FINAL DEVELOPMENT PLAN APPLICATION

PROPERTY INFORMATION			
Project/Property Address: Hamilton Road		Project Name/Business Name: Orthopedic One	
Parcel #: 025-013767	Zoning: (see Map) SCPD	Acreage:	9.13

PLAN SPECIFICATIONS
Project Description & Proposed Use(s): Proposed 60,000 SF medical office building and associated infrastructure to be developed on a 9.13 acre site northeast of the intersection of Tech Center Drive and Hamilton Rd.

RE: Response Letter #1
Project Hamilton Rd Ortho One Final Development Plan

SITE PLAN

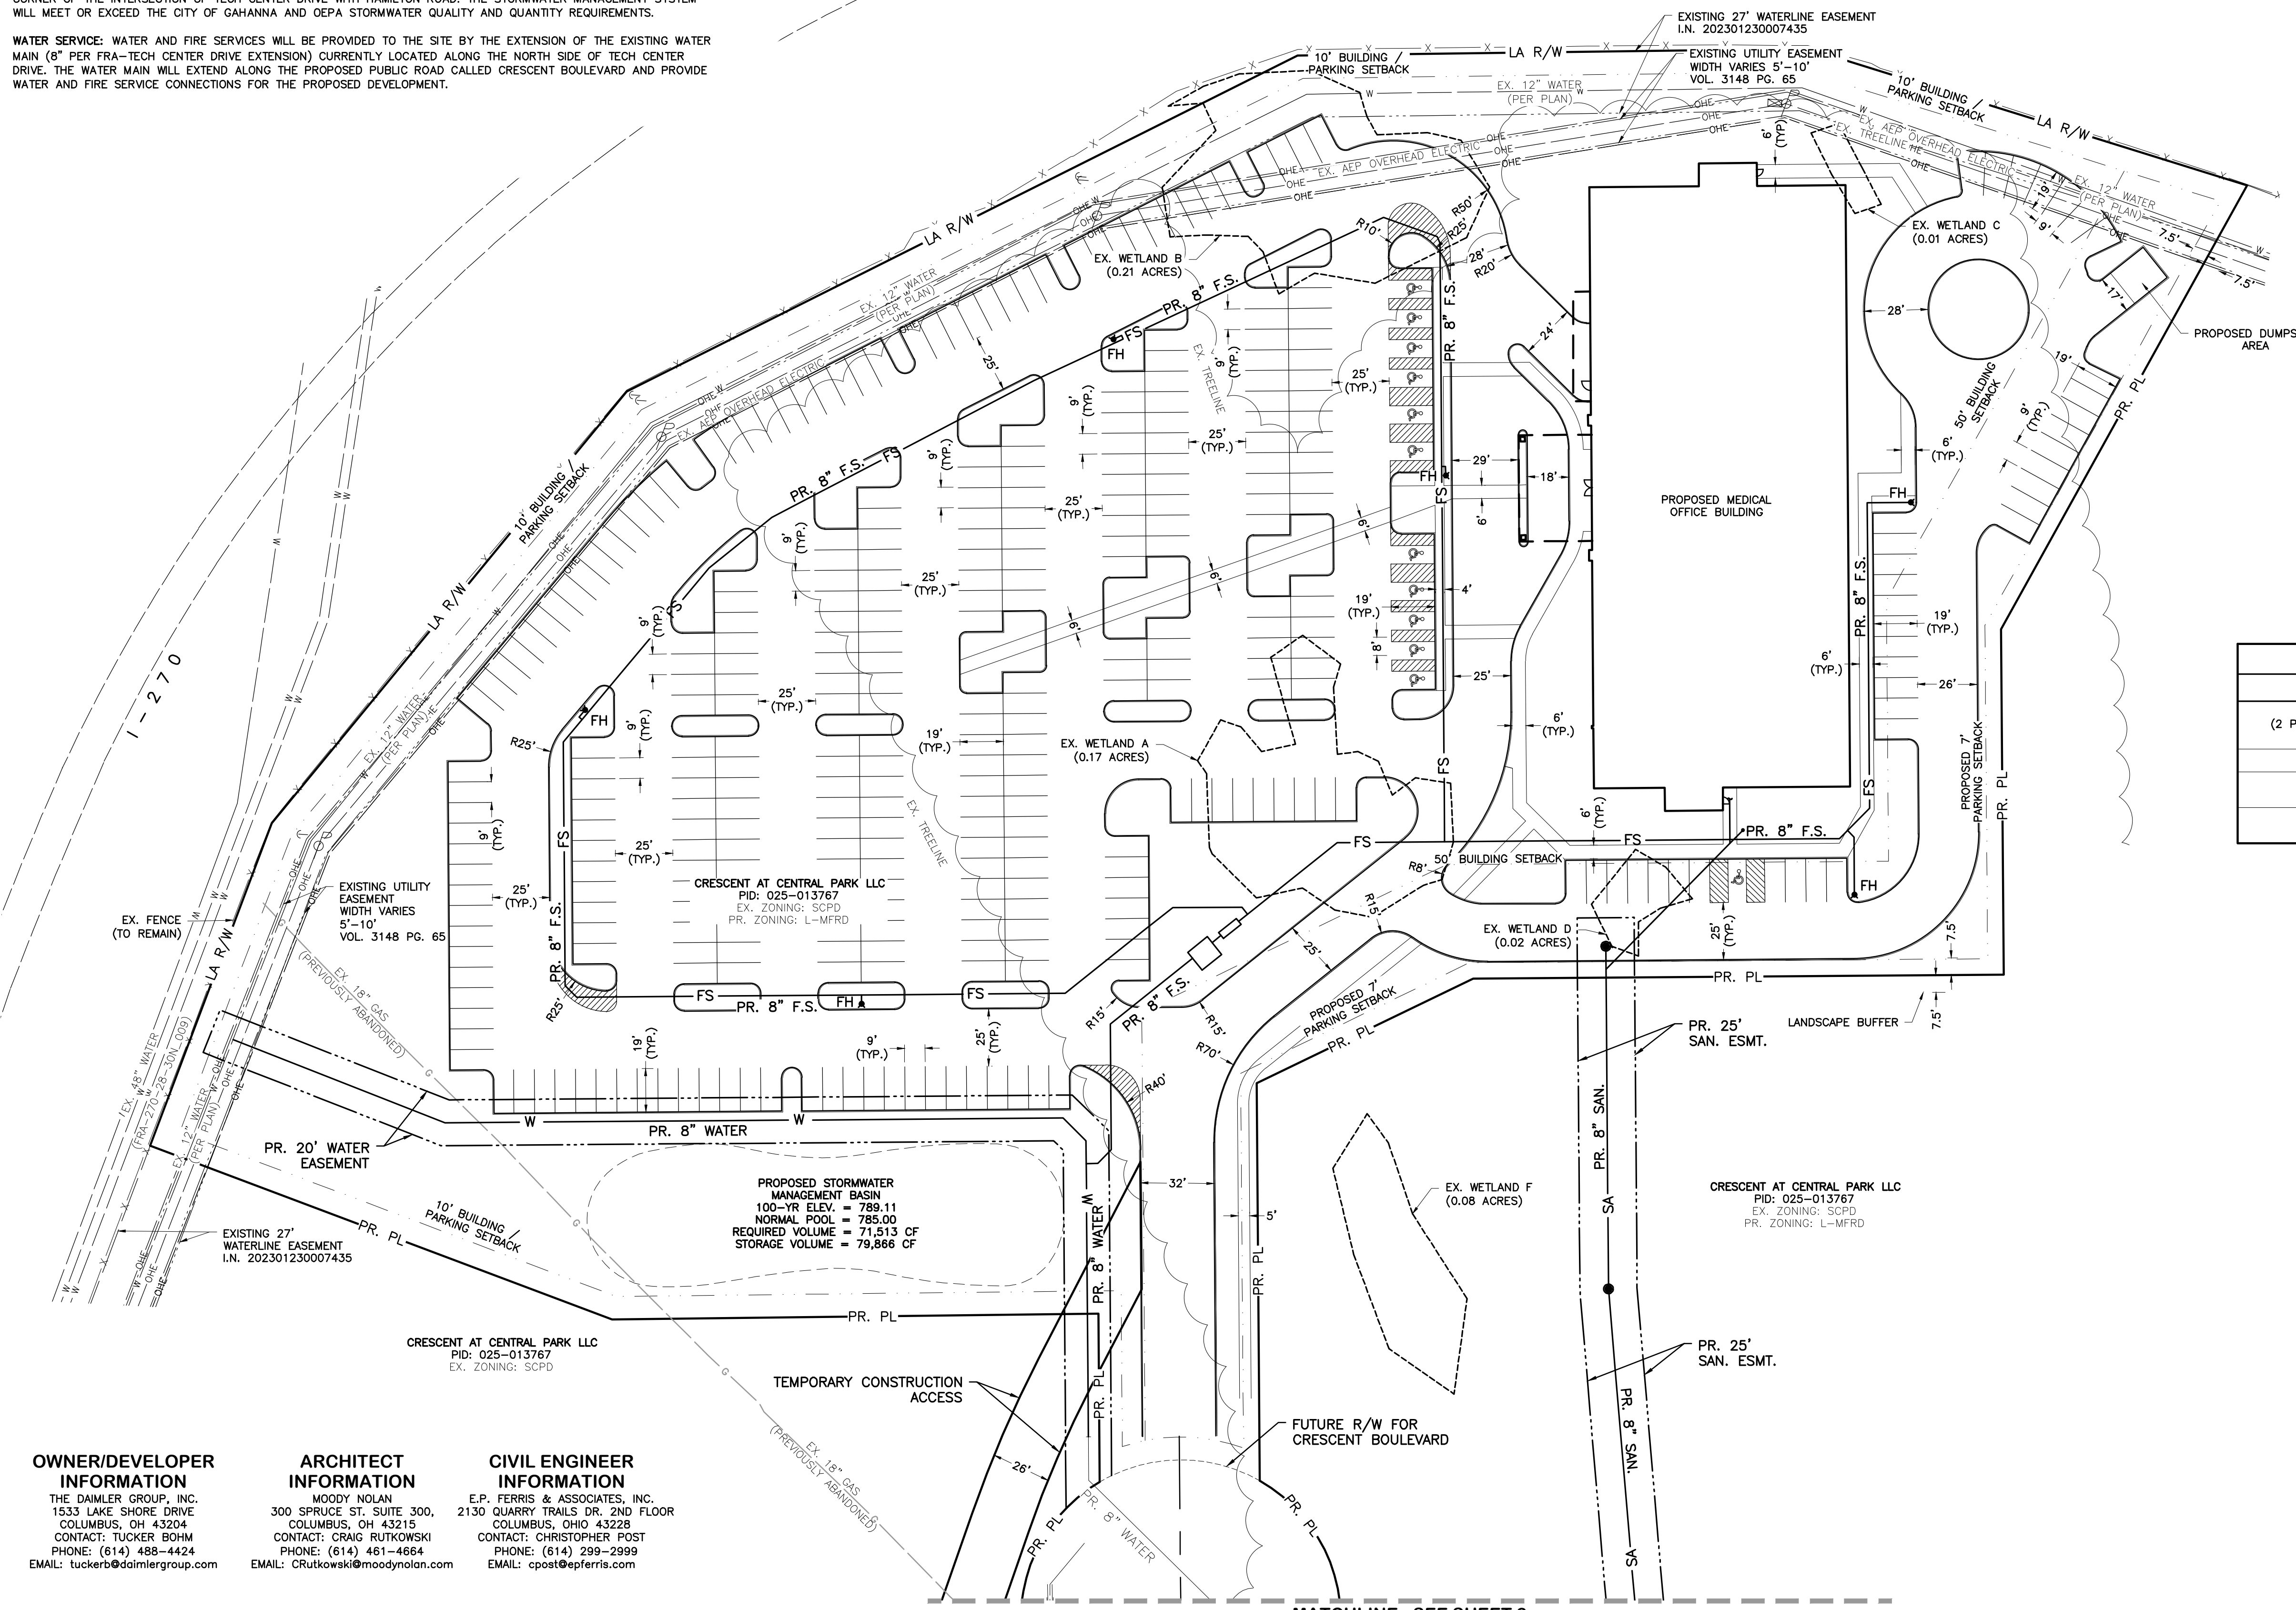
18. The "general zoning info" table on the site plan states that there is a variance to reduce the parking setback along the eastern property lines from 25 ft to 7 ft. This variance needs to be added to the current Variance application.

19. Please remove the "proposed zoning"/L-MFRD row on the "general zoning info" table.

20. Please add the area of just the parking areas to the site data table. Make sure it is consistent with the calculations provided for Ch 1163 interior landscaping requirements.

Response: Will Comply, ADDED TO TABLE. VARIANCE NEEDED FROM SECTION 1151.04(b)(14)

Response: Addressed

Response: Addressed

LANDSCAPE PLAN - OVERALL SITE

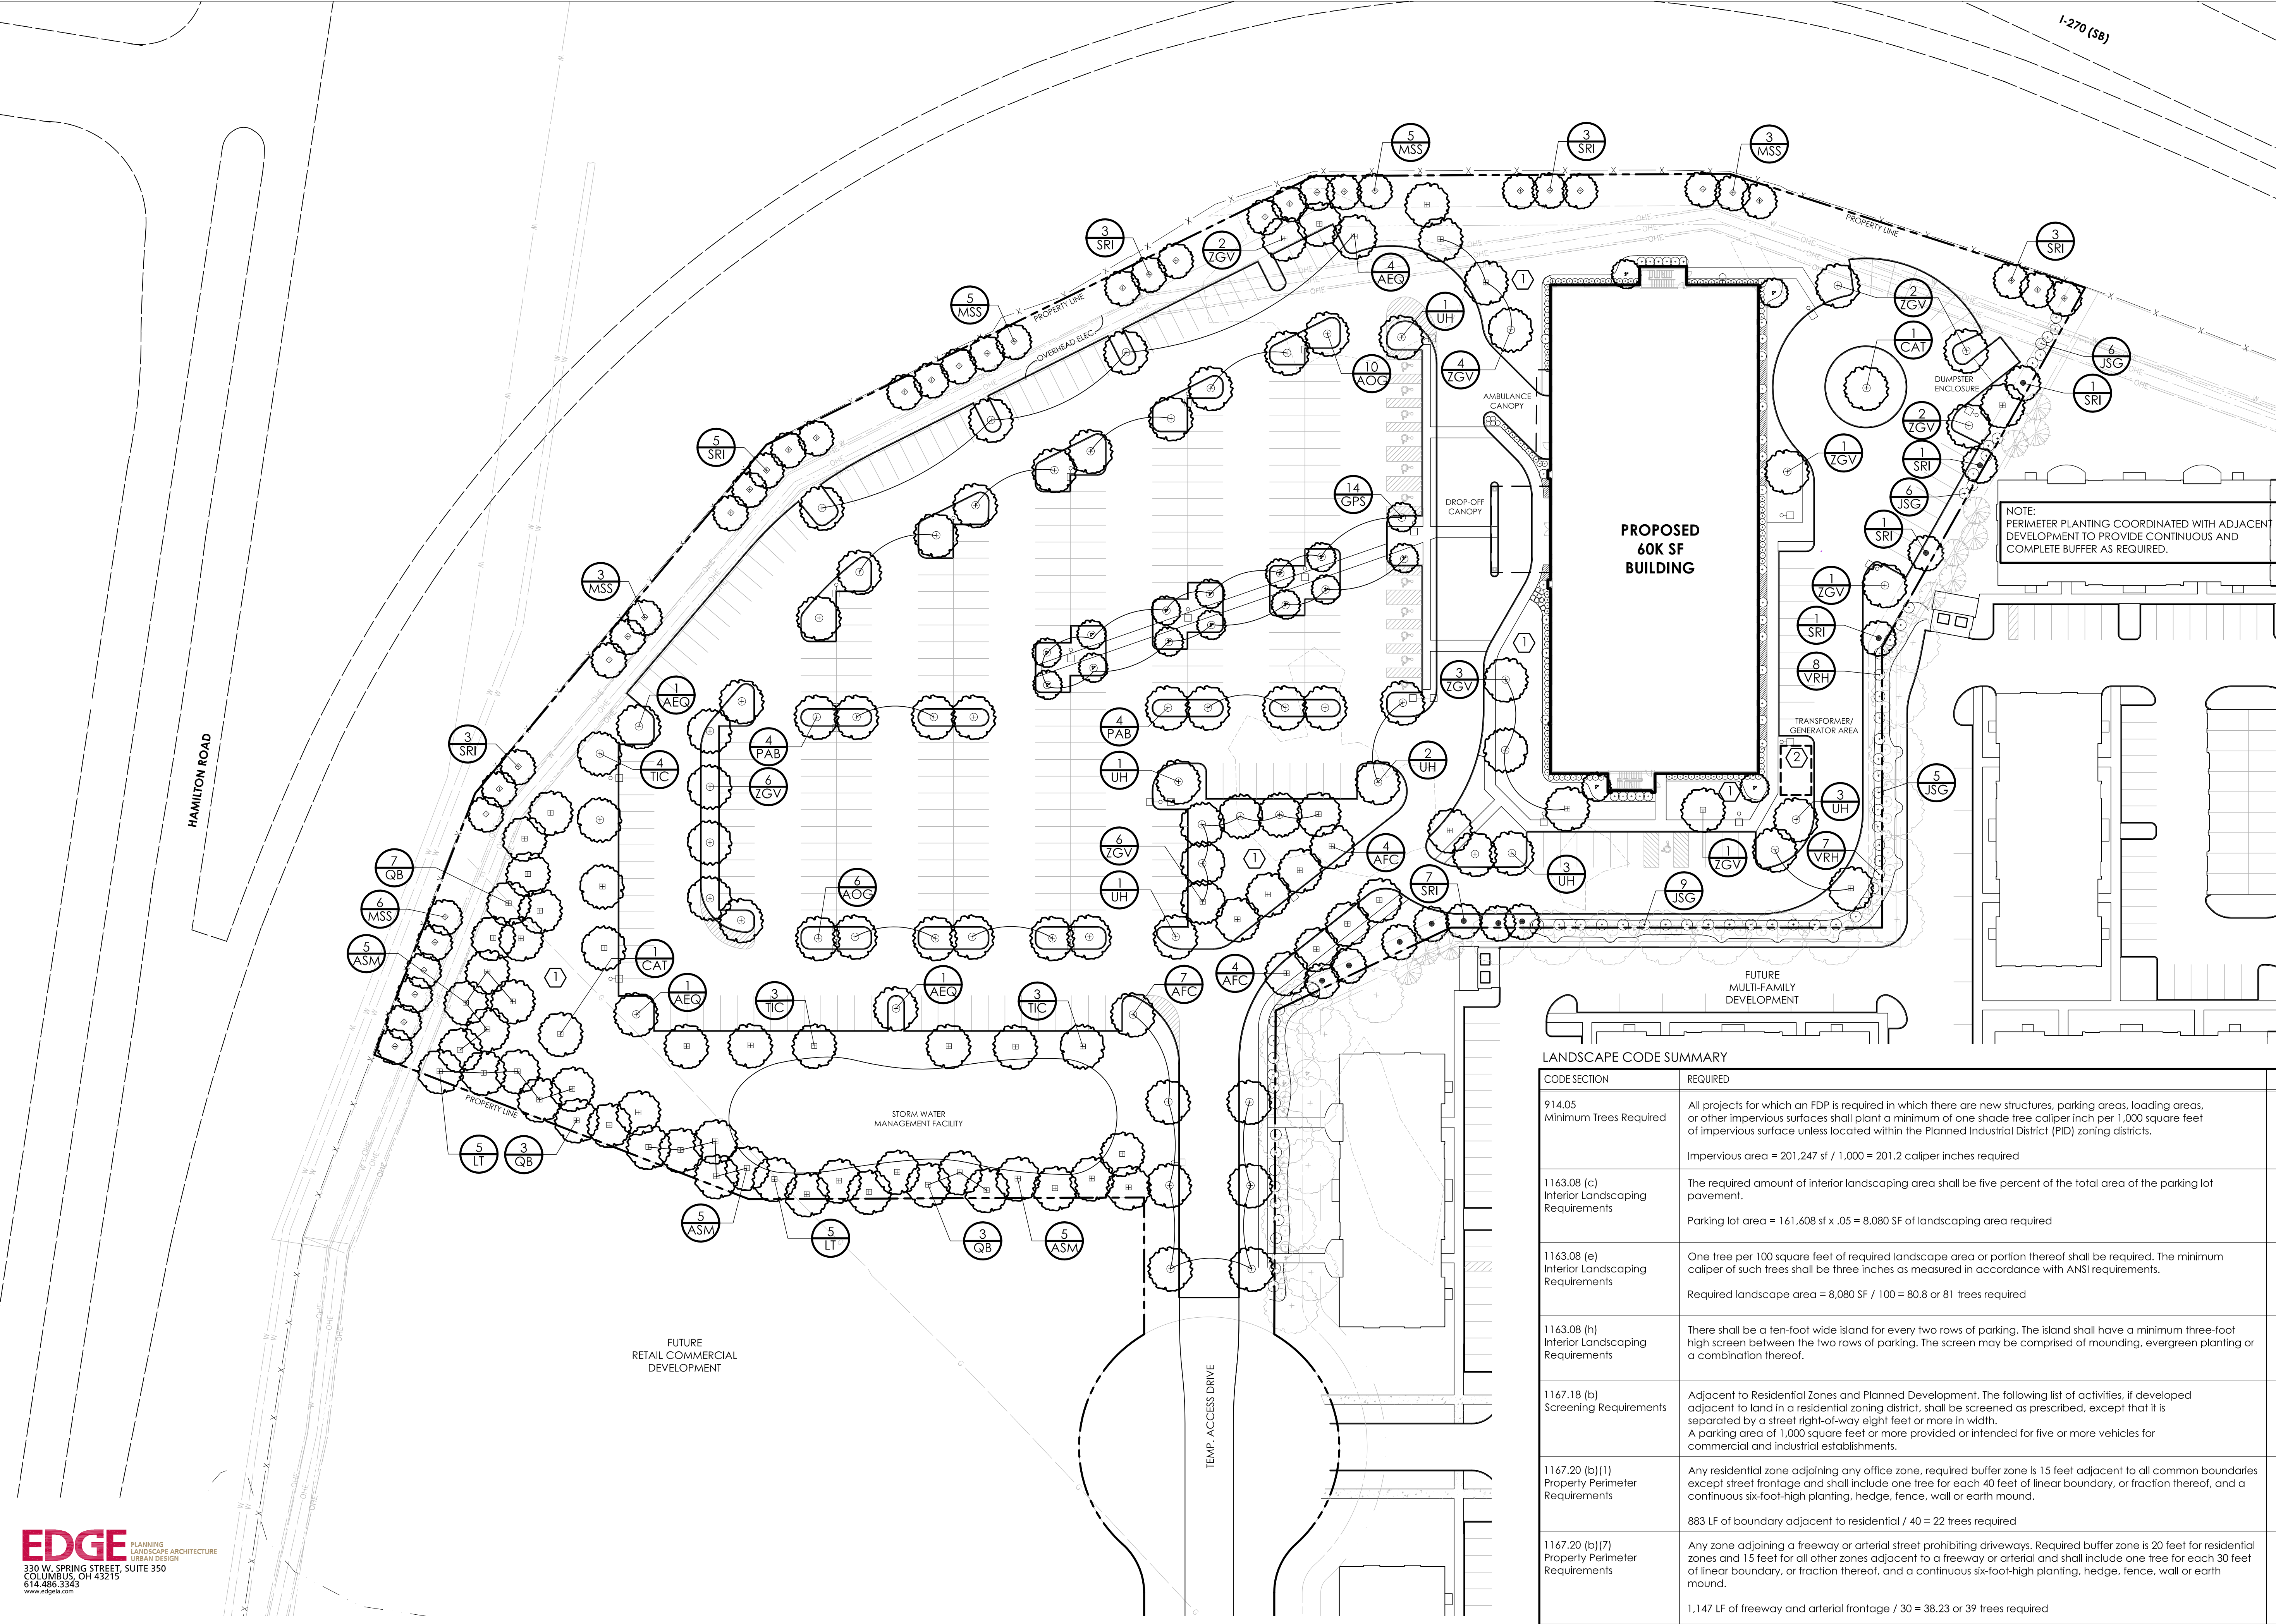
21. On the landscape plan table, the calculations for 1163.08(c) and 1163.08(e) are different. The area calculations for these should be the same since the number of trees required is based off of the area of required landscaping. Please revise.

22. On the landscape plan's table, please revise so the exact Code sections are referenced. The last two need to be changed to 1167.20(b)(1) and 1167.20(b)(7). Please revise in the Variance application as well.

23. For the property perimeter calculations on the landscape plan, the 883 LF should be divided by 40, not 22. Please revise for accuracy.

Response: Will comply and adjusted.

Response: Will Comply

Response: Will clarify and adjust. Calculation still yields 22 trees required.

2 DECID. TREE PLANTING DETAIL
NTS

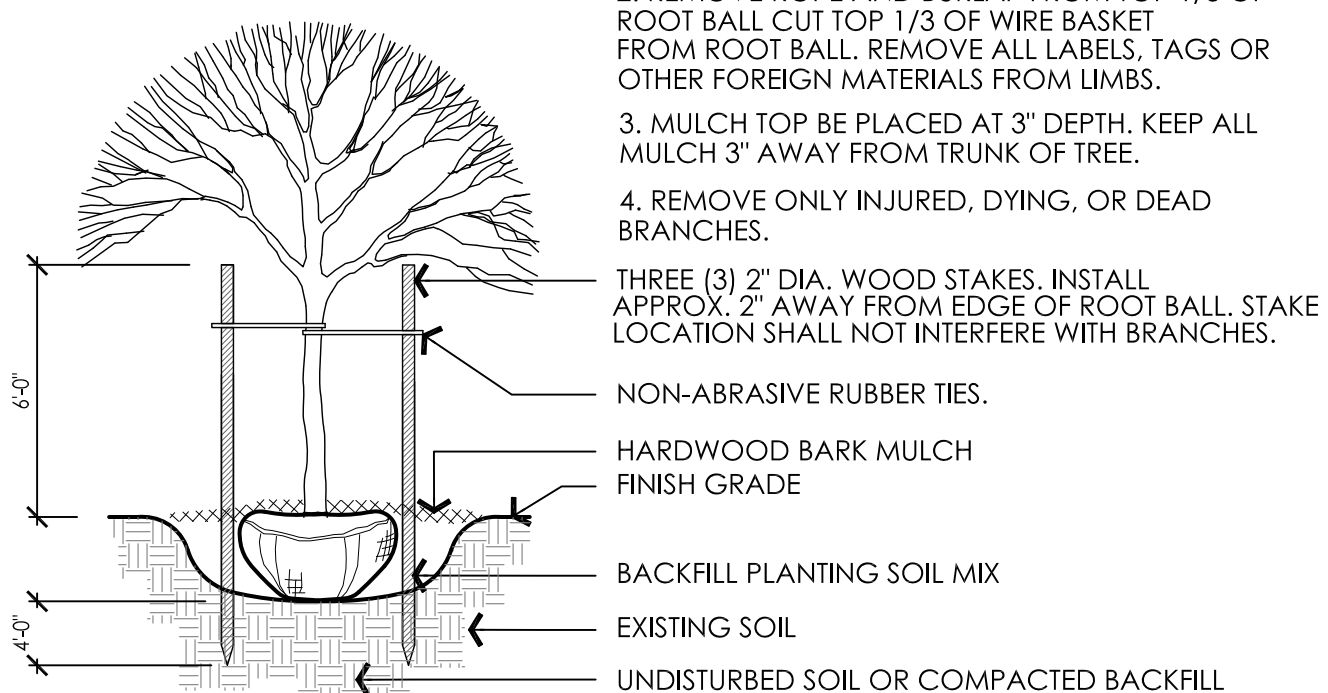
27. Tree planting detail looks appropriate for the most part. If there are broken or damaged branches at planting, these branches should be pruned. Staking should be considered for the first year to prevent trees from leaning.

Response: Notes addressing removal of broken branches are included in written specifications to the contractor but can be added to the detail. Staking will be considered.
